UNITED STATES PATENT AND TRADEMARK OFFICE

APPLICATION NO.	FILING DATE	FIRST NAMED INVENTOR	ATTORNEY DOCKET NO.	CONFIRMATION NO.
10/691,062	10/22/2003	Rainer Bottesch	SCH-00076	6104
7590 11/01/2005 Warn, Burgess & Hoffmann, P.C. P.O. Box 70098 Rochester Hills, MI 48307			EXAMINER HAN, JASON	
			ART UNIT 2875	PAPER NUMBER

Office Action Summary	Application No. 10/691,062	Applicant(s) BOTTESCH ET AL	
	Examiner Jason M. Han	Art Unit 2875

FIG. 6E

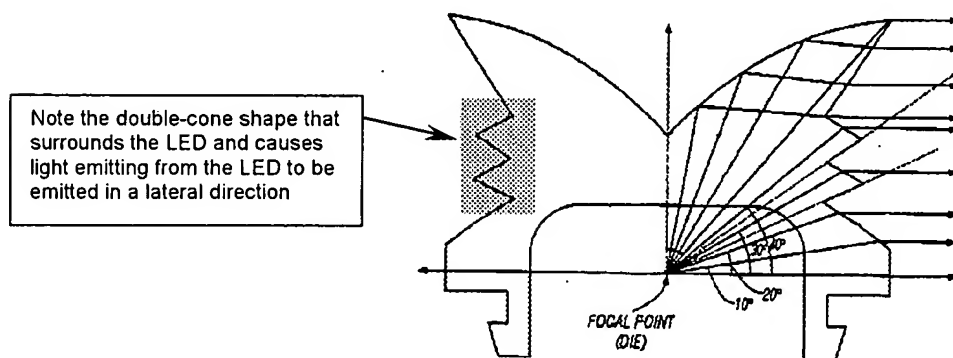
4. Claims 1, 3-5, 7-9, and 13 are rejected under 35 U.S.C. 102(e) as being anticipated by West et al. (U.S. Patent 6598998).
5. West discloses a lamp including:
 - A housing [Figures 5A, 12: (40)] in which at least one light source [Figures 5A, 12: (52)] is arranged, wherein the at least one light source is an LED [Column 3, Lines 27-41];
 - A light-conducting element [Figure 5A: (44); Figure 12: (144)] having a double-cone shape, which surrounds the LED, causing light emitting from the LED to be emitted in a lateral direction; and

- At least one reflection part [Figure 12: (102)] associated with the light source, wherein the at least one reflection part adjoins and surrounds the LED in the same place and has a height that is less than or equal to the LED.
